Subject: Duke Energy Corporation  
Catawba Nuclear Station, Units 1 and 2  
Docket Numbers 50-413 and 50-414  
Proposed Change to Technical Specification (TS) 3.7.9,  
Standby Nuclear Service Water Pond (SNSWP)

On July 26, 2005, the NRC electronically transmitted a Request  
for Additional Information (RAI) to Catawba. The purpose of this  
letter is to reply to this RAI. Attachment 1 to this letter  
contains our reply. The format of the reply is to restate each  
RAI question, followed by our response.

**REPLY TO NRC REQUEST FOR ADDITIONAL INFORMATION**

**SNSWP TEMPERATURE TRENDS**

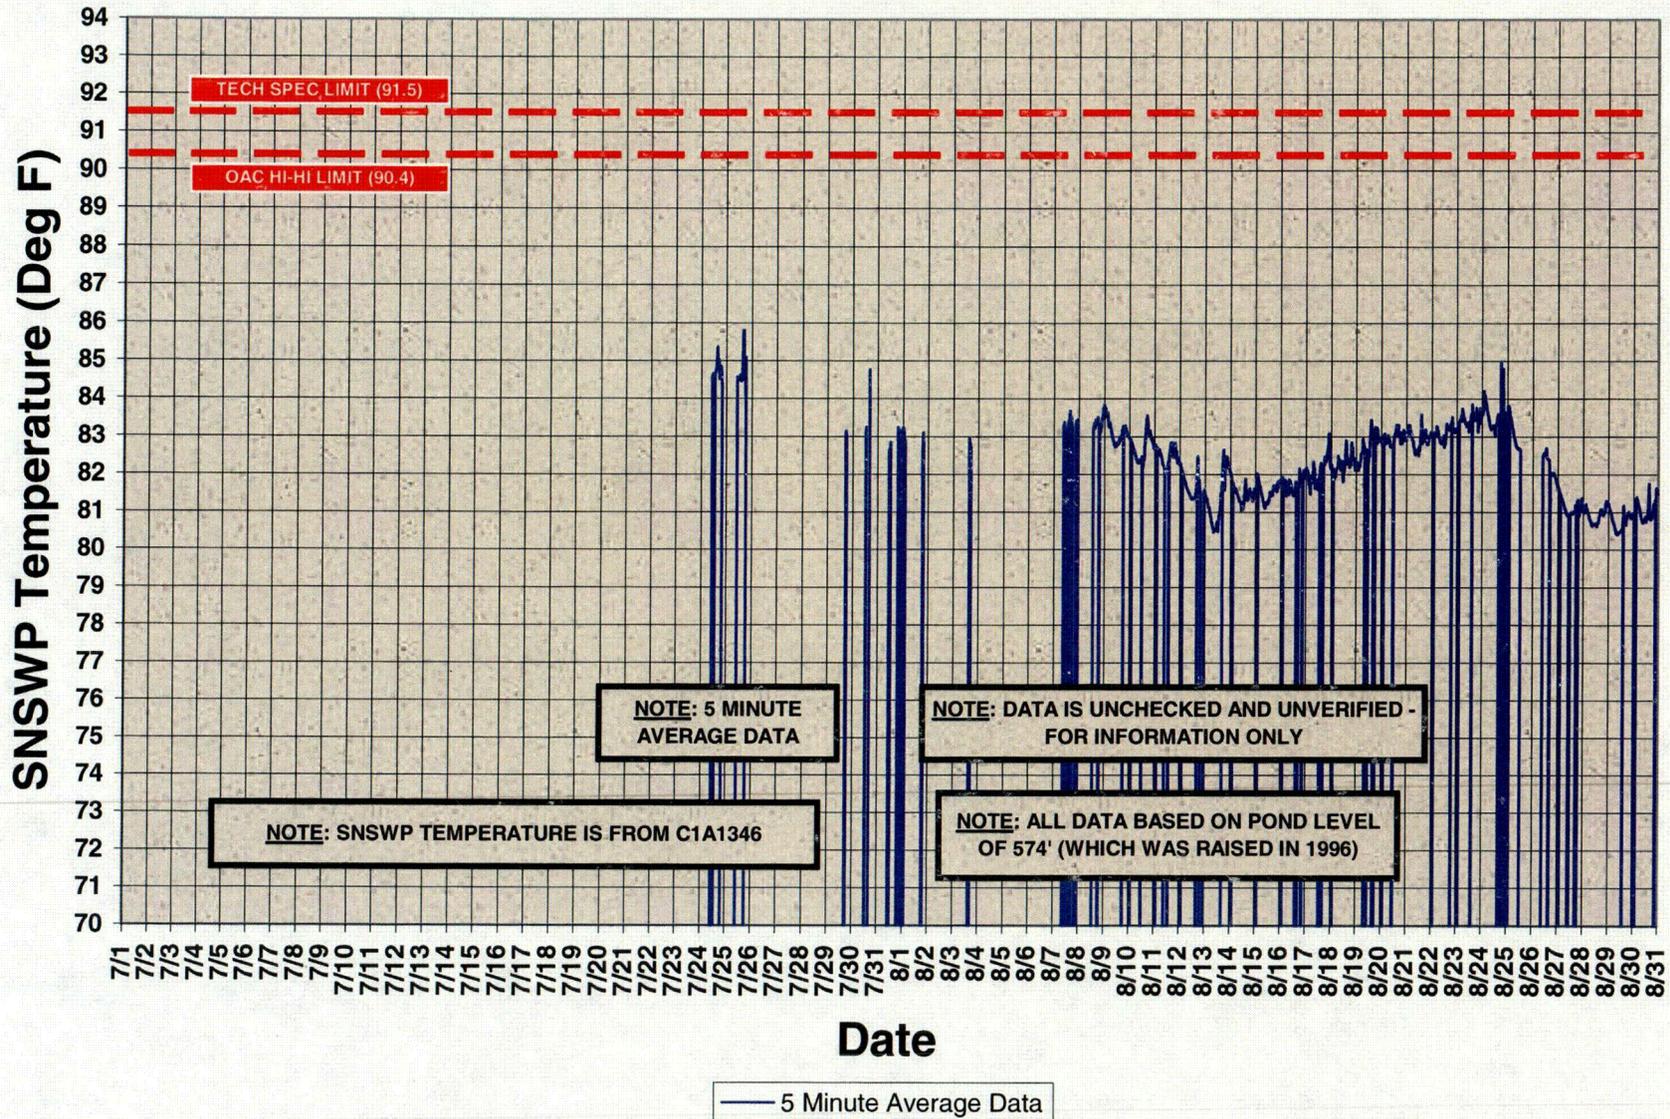
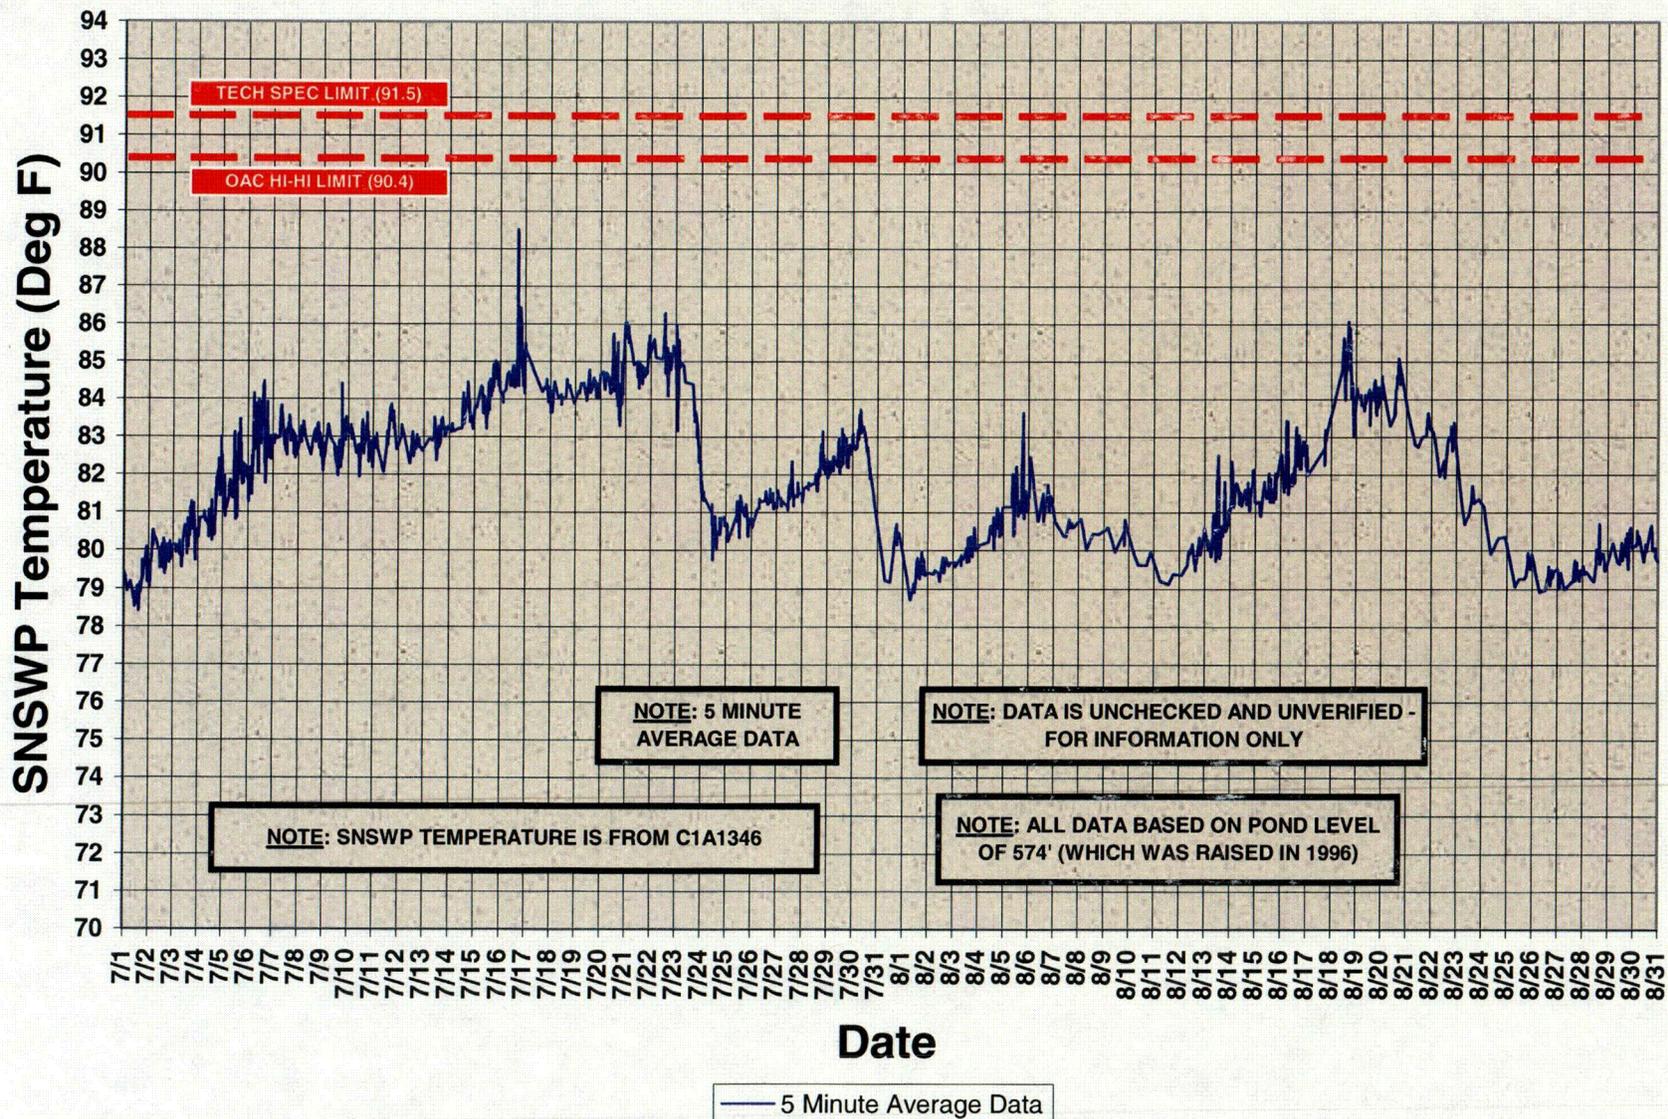
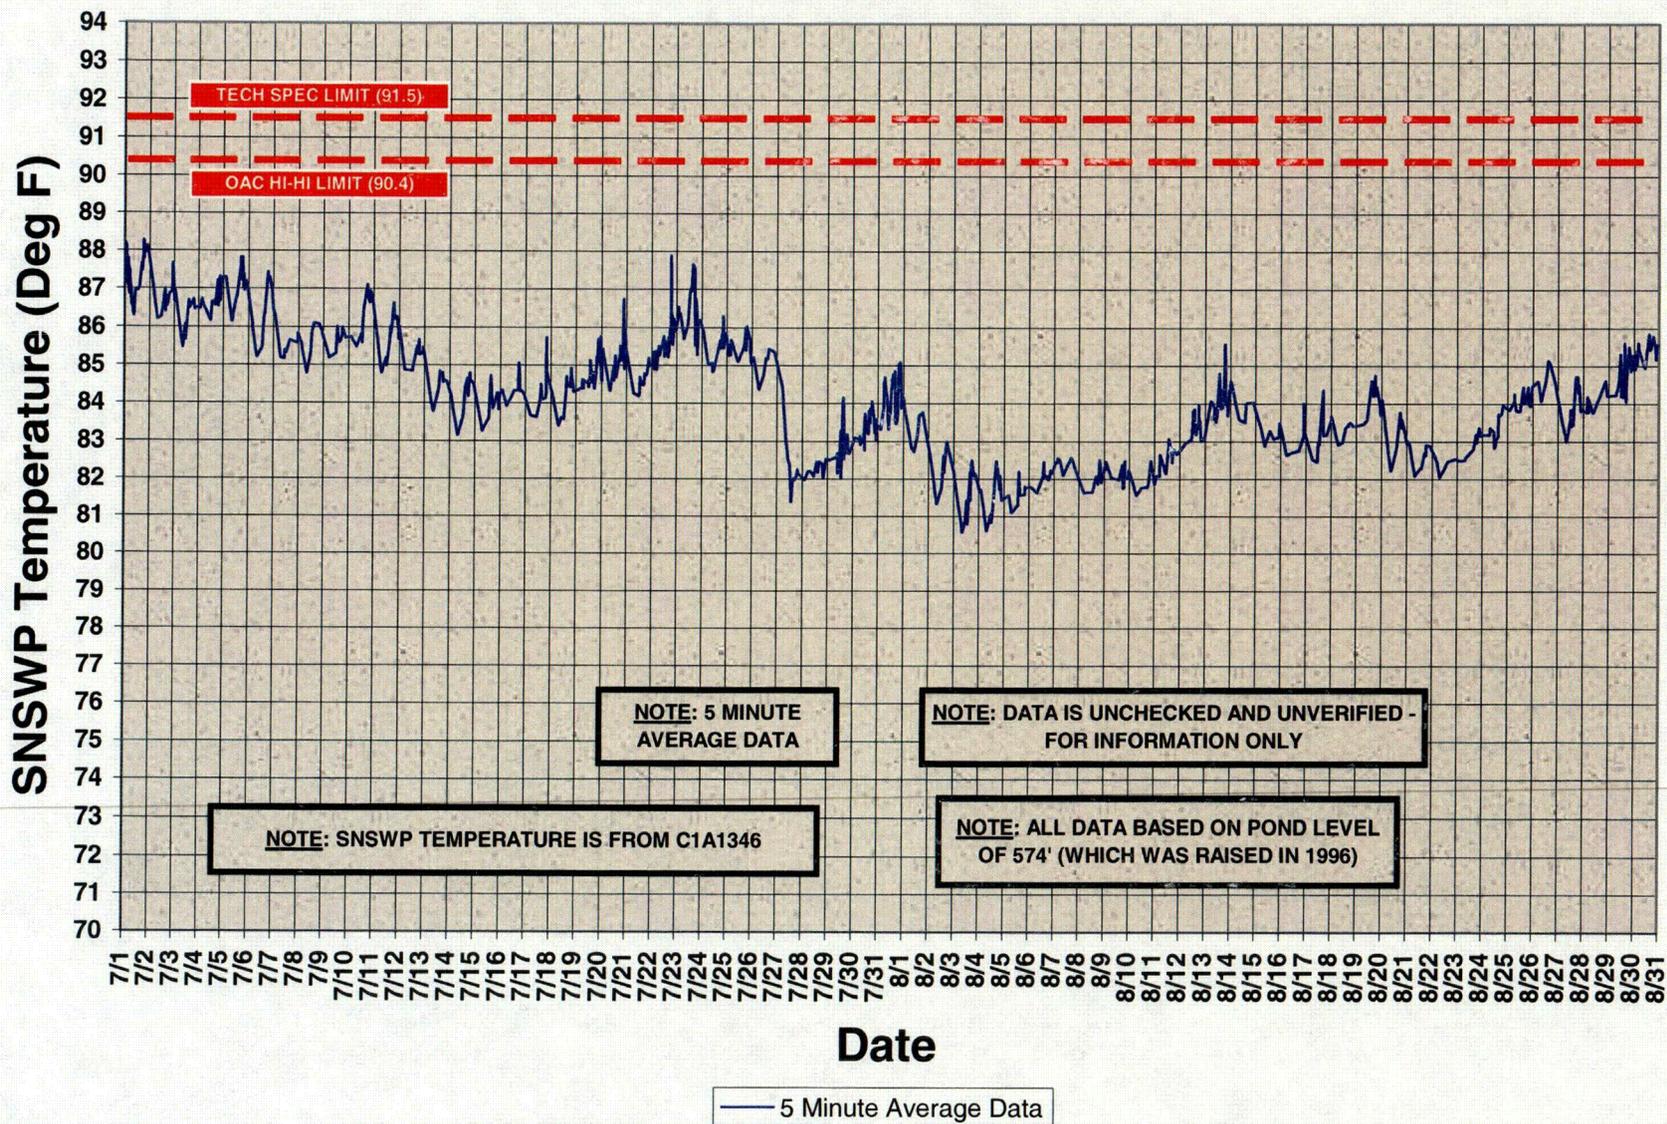
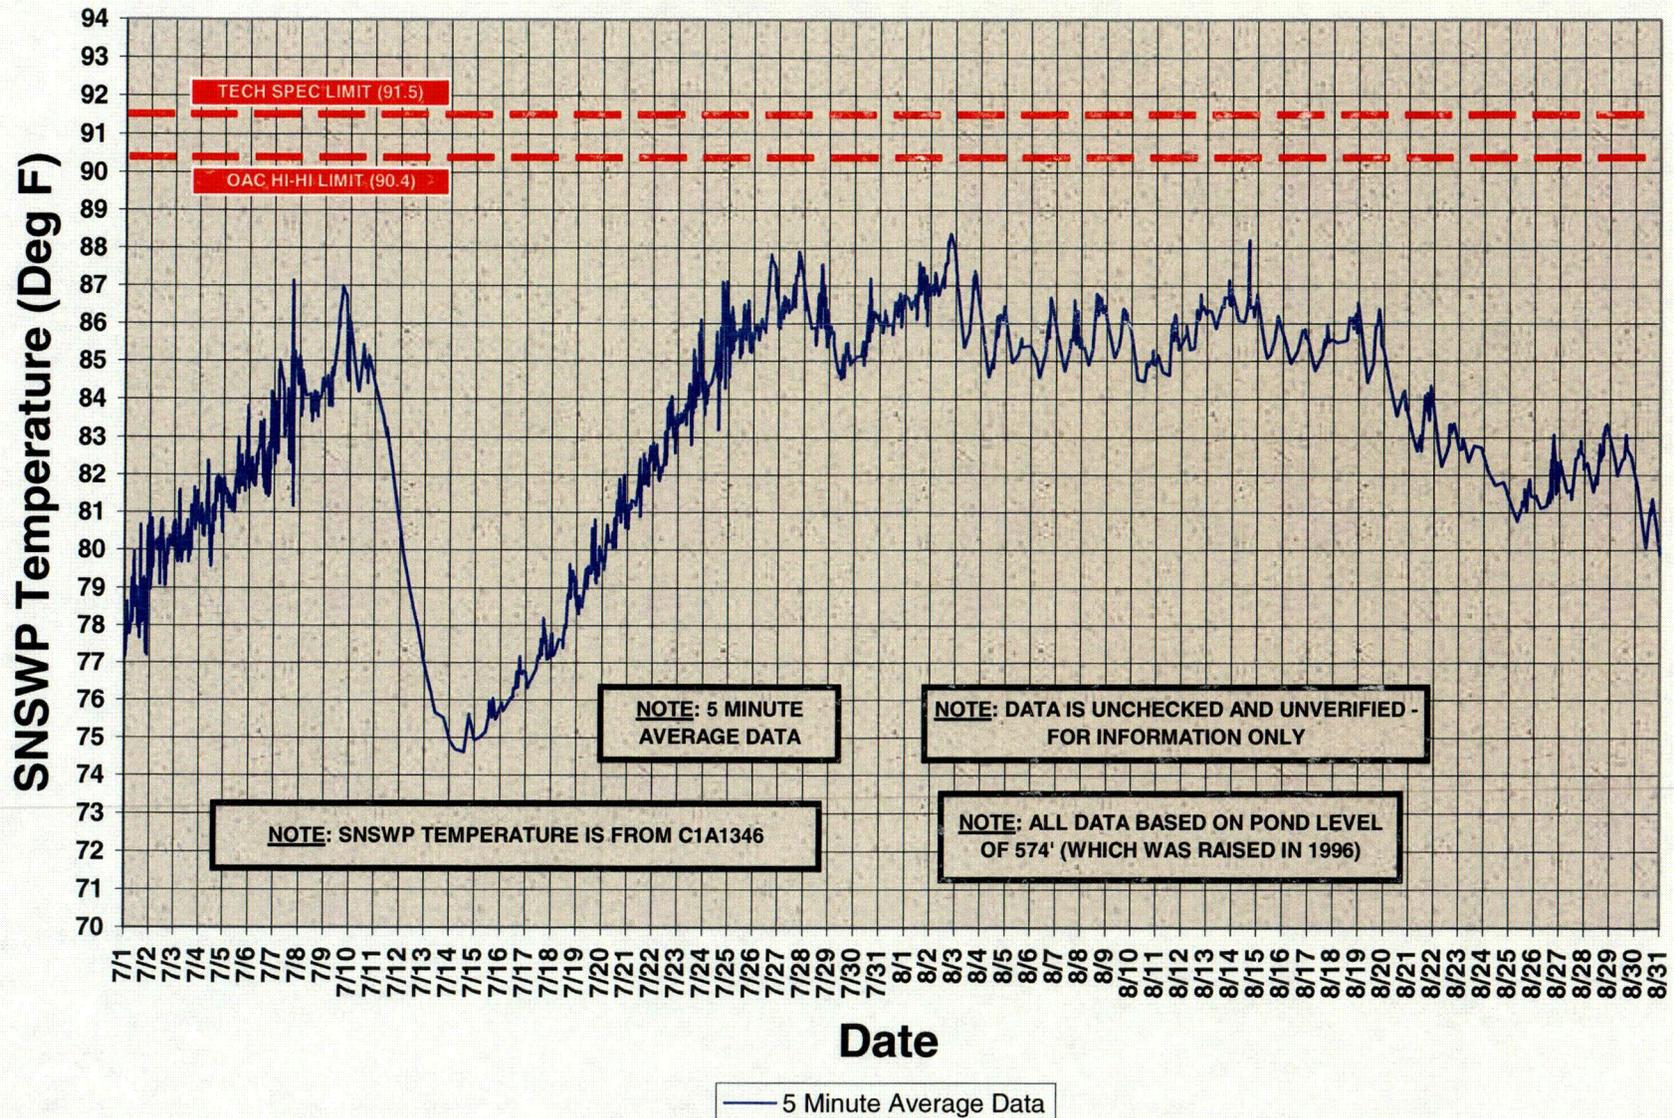
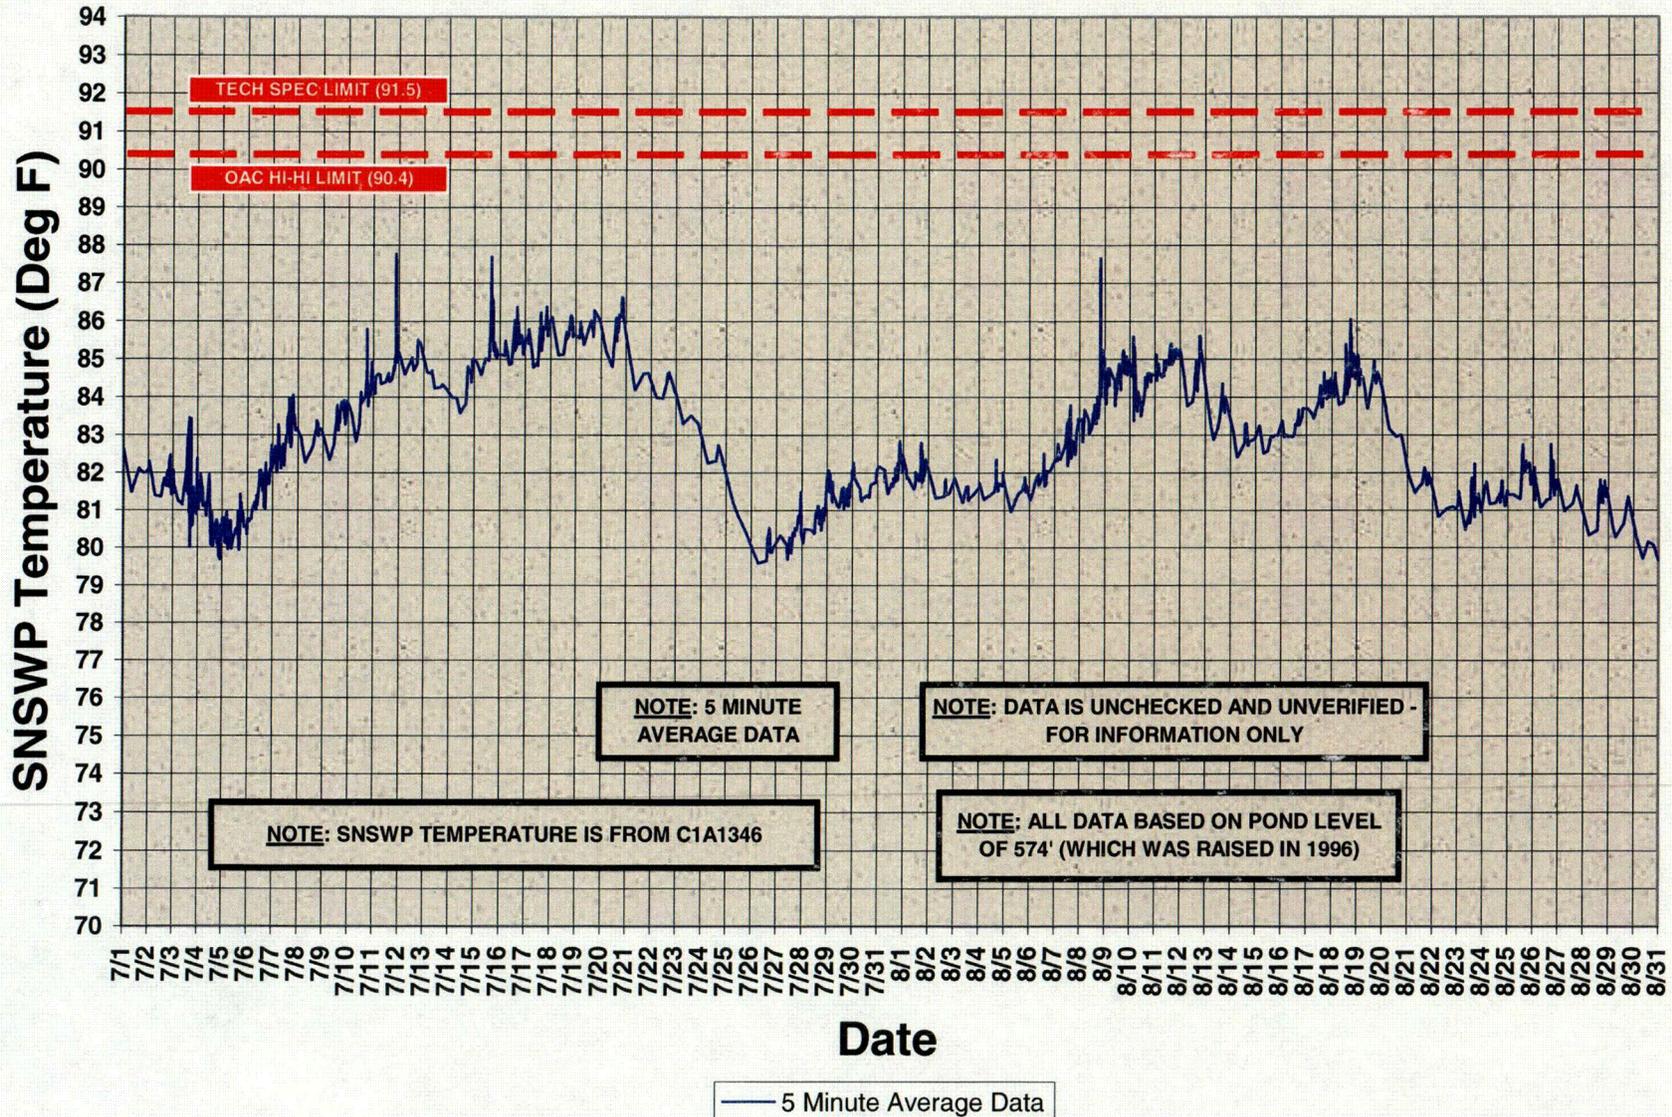
1. Additional information is required in order to demonstrate that the current situation could not have been reasonably anticipated such that an emergency situation pursuant to 10 CFR 50.91(a)(5) exists. Please provide a graphical representation of how the standby nuclear service water pond (SNSWP) temperatures have trended over time (24-hour running average and instantaneous operator/computer values) for the worst two week period of each year since June 1995 to the present, and explain why this information would not cause you to anticipate the elevated SNSWP temperatures that are currently being experienced.

The attached graphs in Enclosure 1 depict how SNSWP temperatures have trended over time during the months of July and August (which includes the worst two-week period of each year for the years 1996 through 2005). There is one graph for each year for 1996 through 2005. The years were chosen to provide a comparison based on the same SNSWP elevation, since elevation can affect measured SNSWP temperature, and elevation was increased to 574 feet in

1996. These graphs utilize 5-minute average data from the Operator Aid Computer (OAC). In addition to graphs for each year, there is also a graph which compares 2005 temperatures with the historical minimum, maximum, and average temperatures for the years 1996 through 2004.

The data in Enclosure 1 indicates short term spikes of up to 89°F during the hot summer months. In the 20 plus years of operating history, there has never been a forced shutdown of a Catawba unit due to SNSWP temperature. Therefore, there was no reason, based on historical data, to anticipate the need for an emergency TS change. However, Catawba did identify the need for additional operating margin in case the historical weather patterns became more challenging. Catawba has been working on the analysis to support this amendment for several months prior to the submittal. Beginning several weeks ago, Catawba began experiencing an extended stretch of hot, humid weather that resulted in an upward trend in SNSWP temperature of approximately 0.4°F per day and increasing Lake Wylie temperatures. Catawba has also historically experienced short term spikes of up to 3°F due to late afternoon rain shower runoff, where the runoff picks up heat from the SNSWP surroundings. Based on the trend, the potential rain runoff concern, and predictions of continued hot and humid weather, Catawba management decided it was prudent to expedite the completion of all required analysis to support raising the SNSWP temperature limit and to submit an emergency TS amendment. In the meantime, Catawba has been aggressively making up to the SNSWP during times of relatively low Lake Wylie inlet temperature in an effort to slow the upward trend in SNSWP temperature. These efforts have slowed the rate of increase of SNSWP temperature. Temperature reached 88.4°F on July 27, 2005. These measures will not be effective indefinitely without a break in the weather. Therefore, continued SNSWP temperature increases over the next few days, and/or a short term temperature spike, could result in exceeding the existing TS limit.
